Certificate of Appropriateness

Property 2674 N. SUMMIT AV. North Point North Historic District

Description of work Rebuild front porch deck and walls. Salvage all original brick and stone to be used in

Date issued 2/7/2013 PTS ID 85500 COA, front porch rebuild

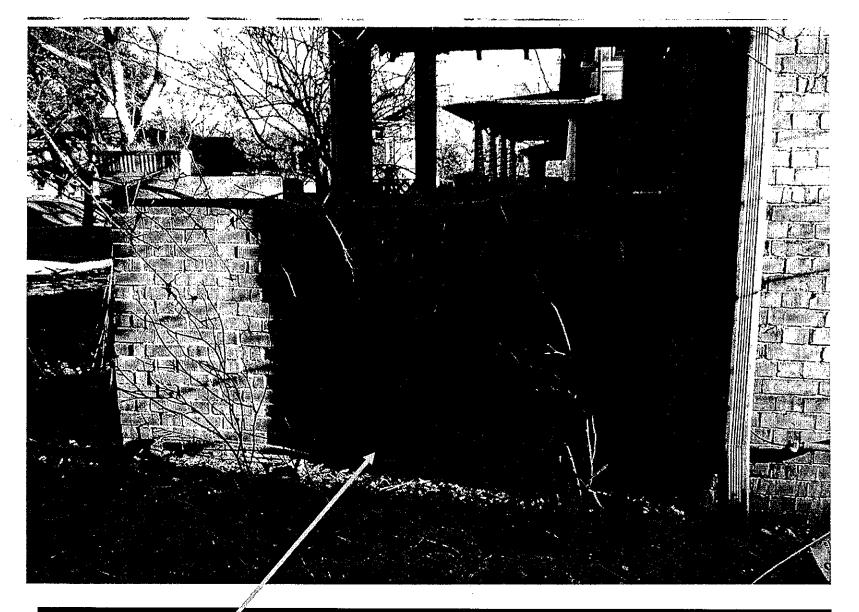
Rebuild Front Porch using salvaged brick and stone. Design will remain unchanged. New wood railings will match exactly the existing railings.

No change to design and mortar color, texture hardness, joint width and joint finish must match the original on the house.

Porch will be rebuilt in exactly the same footprint as the original
